## HISTORIC AND DESIGN REVIEW COMMISSION

October 17, 2018

**HDRC CASE NO:** 2018-517  
**ADDRESS:** 215 NELSON AVE  
**LEGAL DESCRIPTION:** NCB 3888 BLK 4 LOT 16  
**ZONING:** RM-4  
**CITY COUNCIL DIST.:** 2  
**DISTRICT:** Knob Hill Historic District  
**APPLICANT:** Jordan Mengele/SoTex Property Brothers  
**OWNER:** Jordan Mengele/SoTex Property Brothers  
**TYPE OF WORK:** Install concrete driveway, modify accessory structure  
**APPLICATION RECEIVED:** September 19, 2018  
**60-DAY REVIEW:** November 18, 2018  
**REQUEST:**

1. Amend the previously approved ribbon driveway to instead install a fully paved concrete driveway.
2. Modify existing accessory shed to function as garage.

Requesting to Convert Shed  
to Garage

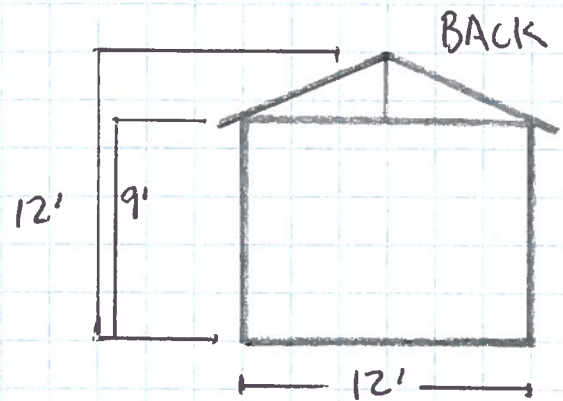
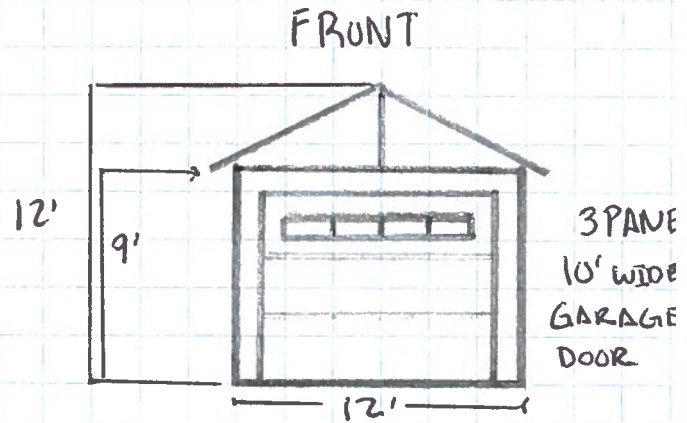
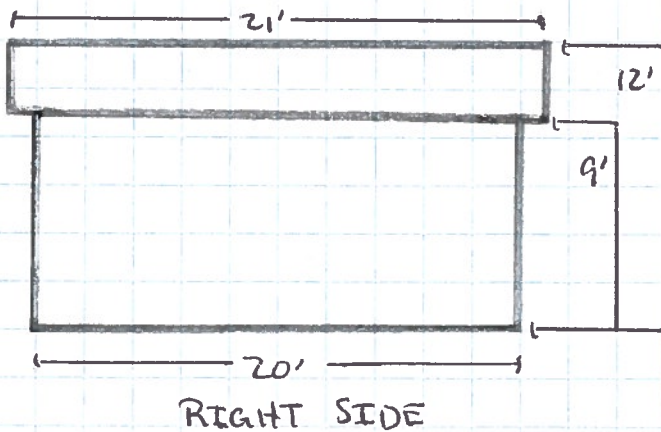
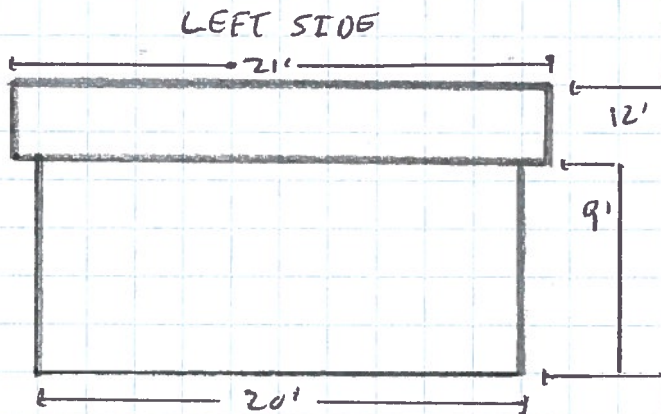
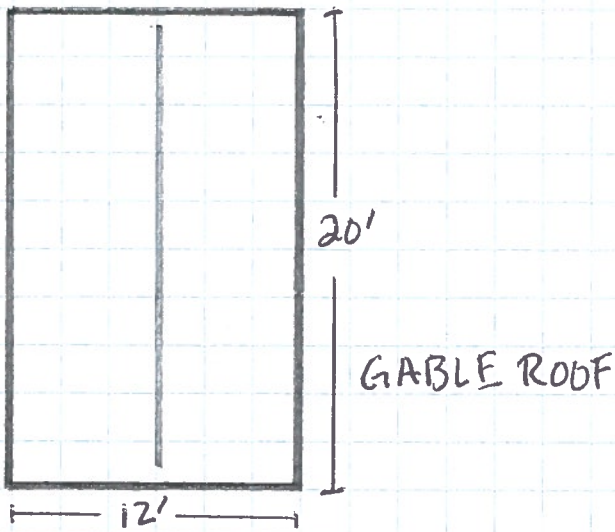
- d. ACCESSORY STRUCTURE MODIFICATIONS – The applicant has proposed to keep the structural framing including the footprint and general form intact, while replacing the board-and-batten with wood lap siding, the carriage doors with a three-panel garage door and installing a composition shingle roof. Staff finds that the proposed modifications are inconsistent with the Guidelines for Maintenance and Exterior Alterations 9.B.ii noting that replacements should be made in-kind using similar scale, proportion, color, and materials as the original historic structure. Staff also finds the alteration from the carriage door to the three panel garage door is inconsistent with the Guidelines, noting that replacement doors should be compatible with those found on historic garages in the district as well as with the principal structure, especially when visible from the public right-of-way.

- 2 - Requesting approval to convert the existing shed into a garage.

On September 5<sup>th</sup> 2018 we received approval to demo the existing shed. The bones (2x4s) of the shed are in good shape and many of the 2x4s can be saved. We are seeking approval to convert the existing shed into a one car the garage (12'x20'). The siding on the existing shed is in bad shape and will need to be replace with 117 siding to match the siding on the home. The old siding on the shed will be donated to an antique store to be repurposed. The roof will be the same material as the home to match. When I was attending the last meeting on September 5<sup>th</sup> a few home owners around the area were concerned about theft and they all mentioned they don't have a garage, I can see having a garage as a huge benefit to a home owner giving them added security as protection for their belongings. A few homes on the block have garages, the next door neighbor being one of them.

1. Staff recommends approval of item #1 the installation of a ribbon driveway with the stipulation that the width does not exceed ten (10) feet.
2. Staff recommends approval of item #2, the repair of the rear accessory structure and the necessary modifications to function as a garage based on finding c and d with the following stipulations:
  - i. That the replacement items are made in kind/
  - ii. That the applicant submit to staff a garage door detail that relates to the existing carriage doors in material and profile.

Requesting Solid One Car  
Driveway Instead of Approved Rib  
Driveway

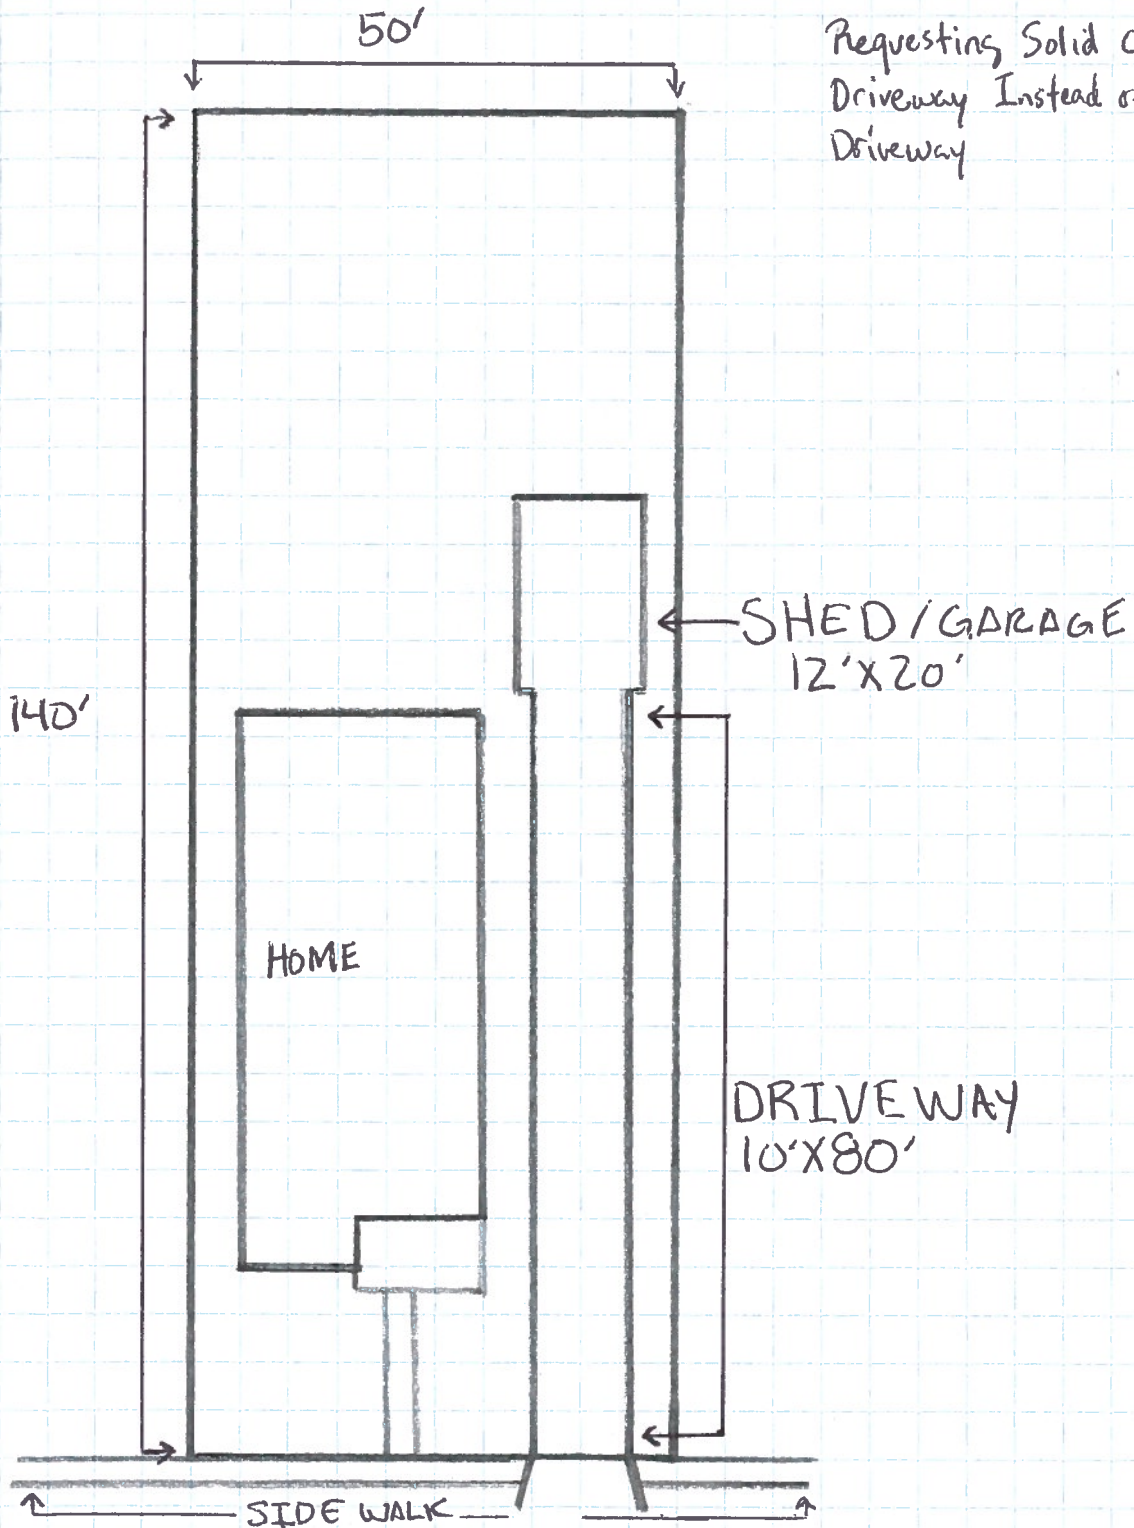
- b. DRIVEWAY – The applicant is requesting approval to amend the previously approved installation of a ribbon driveway to instead feature a fully paved concrete driveway with a matching dimension (10 feet wide by 80 feet long). The property currently features only a deteriorated driveway apron leading to a natural lawn. One ribbon driveway is found with a Craftsman style residential structure on the block while the rest feature poured concrete or unpaved driveways. The Guidelines for Site Elements 5.B.a. note that driveway configurations should incorporate materials, width, and design of the driveway that would be historically found on the lot. Driveways should feature a width no wider than ten feet and minimal impervious paving to increase storm water filtration. While staff finds that a fully paved concrete driveway is appropriate, staff encourages the applicant to commit to the previously approved ribbon driveway to reduce the installation of new impervious surfaces.

- 1 - Requesting approval to install 10'x80' solid driveway.

On September 5<sup>th</sup> 2018 we received approval to install a ribbon driveway however after talking to several contractors they all recommend installing a solid driveway due to the soil in the area. All contractors state that the soil on the lot is prone to shifting and will cause the ribbon driveway to crack and become an eye sore. We are seeking approval to install a one car solid driveway that will be 10ft by 80ft leading up to the garage. Many homes on the block have solid one car driveways.
